# LICENSEE POST-EXAM COMMENTS

BROWNS FERRY 2000-301  
50-259, 260, and 296/2000-301

FACILITY LETTER CONTAINING  
POST-EXAM COMMENTS  
AND THE ENCLOSURES

**BROWNS FERRY NUCLEAR PLANT (BFN) - NRC WRITTEN EXAMINATIONS AND COMMENTS ON EXAMINATION QUESTIONS**

TP-2: RBCCW SYSTEM LOADS

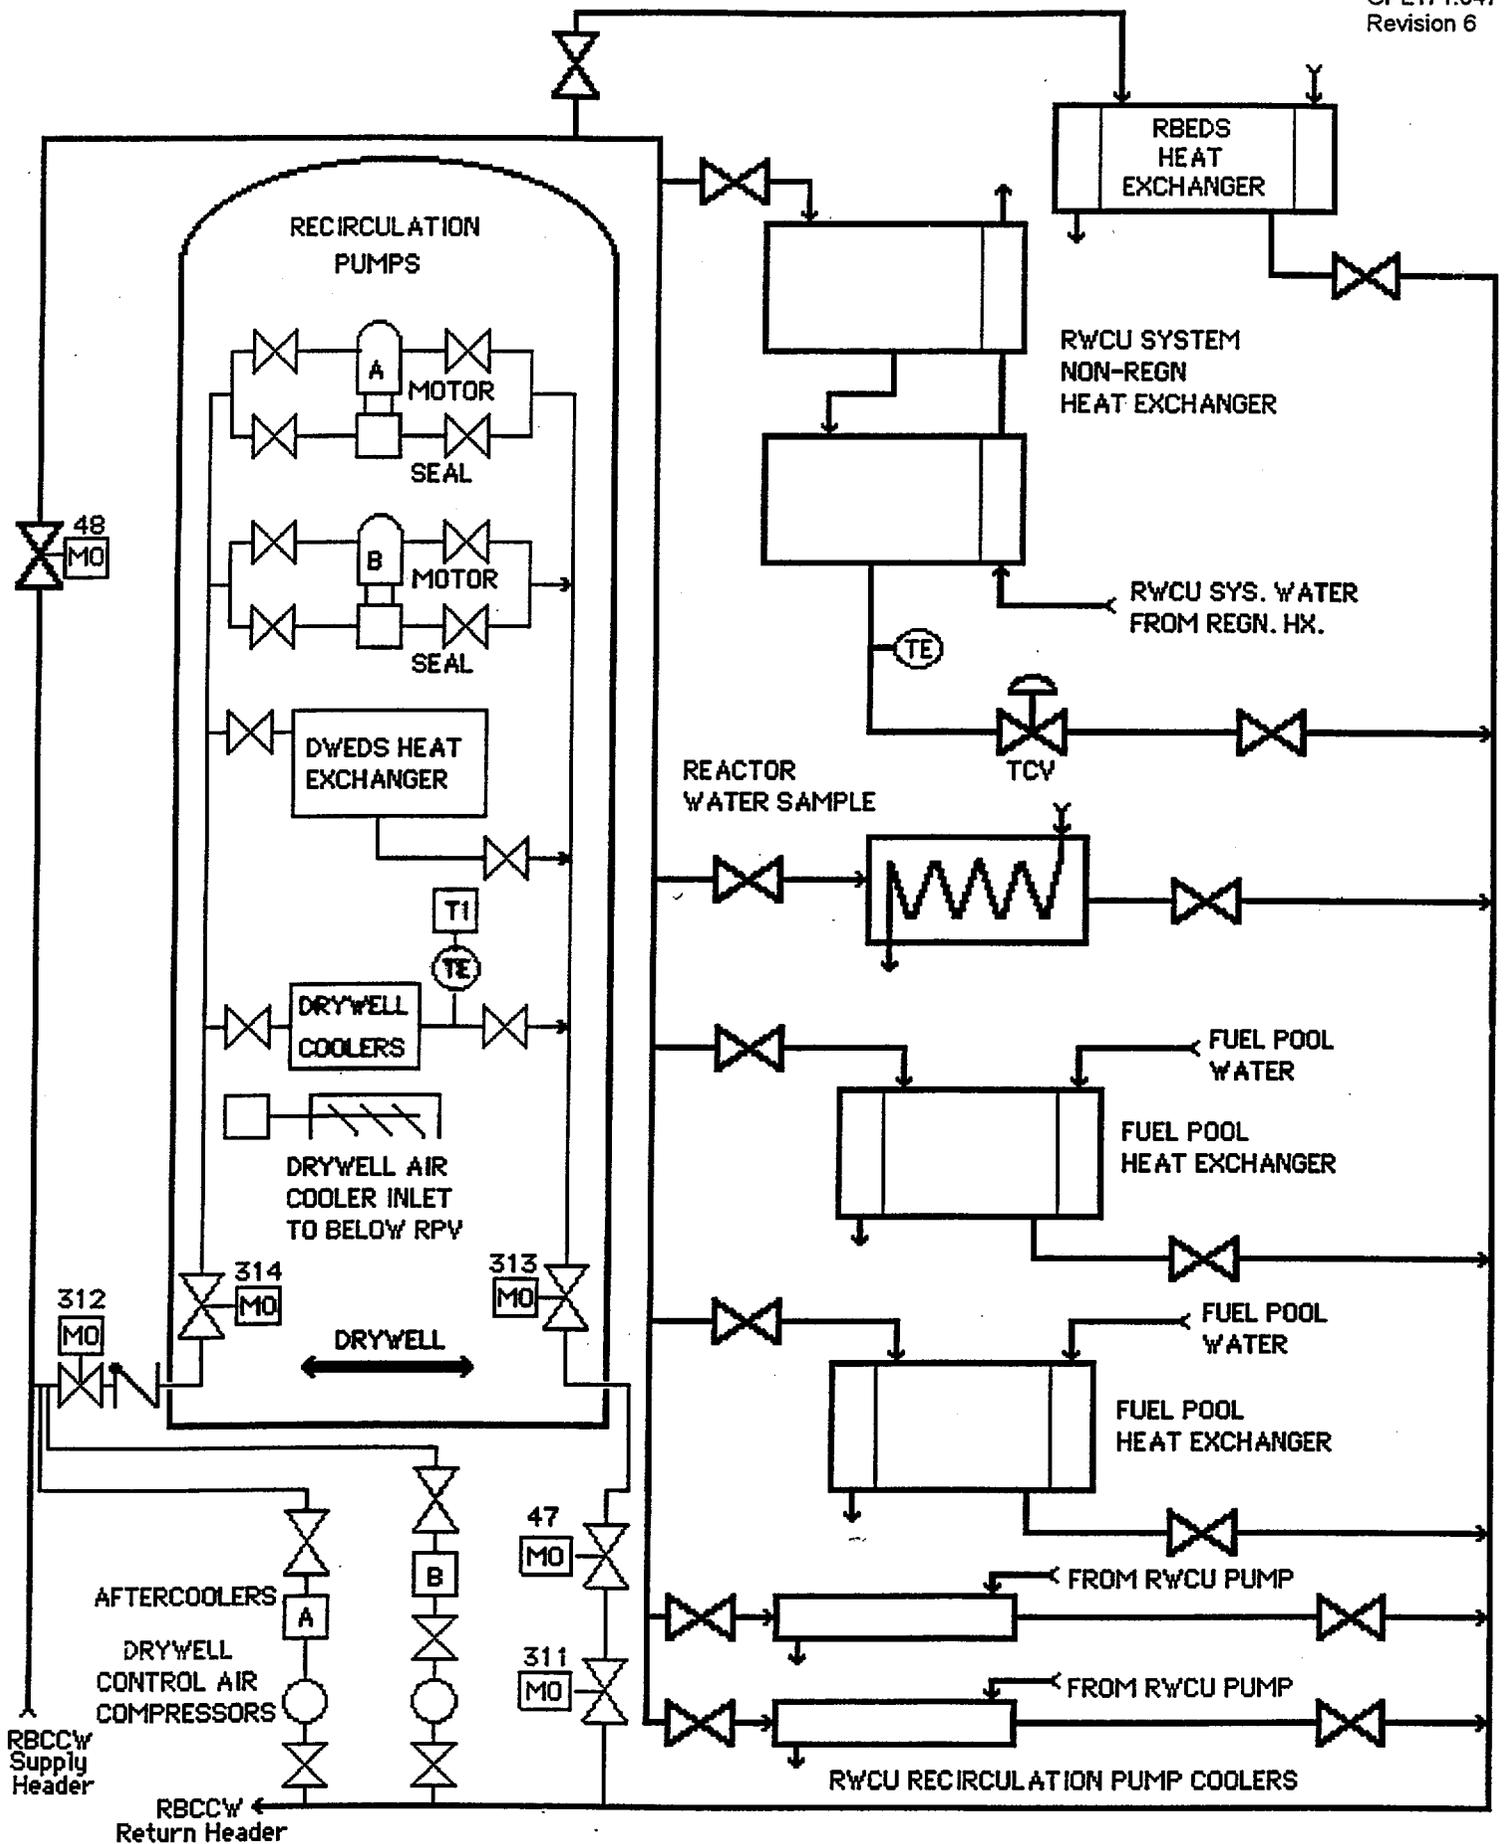
Unit 3 70-48 closes on  
low pressure as a result  
of the pump trips from  
load shed
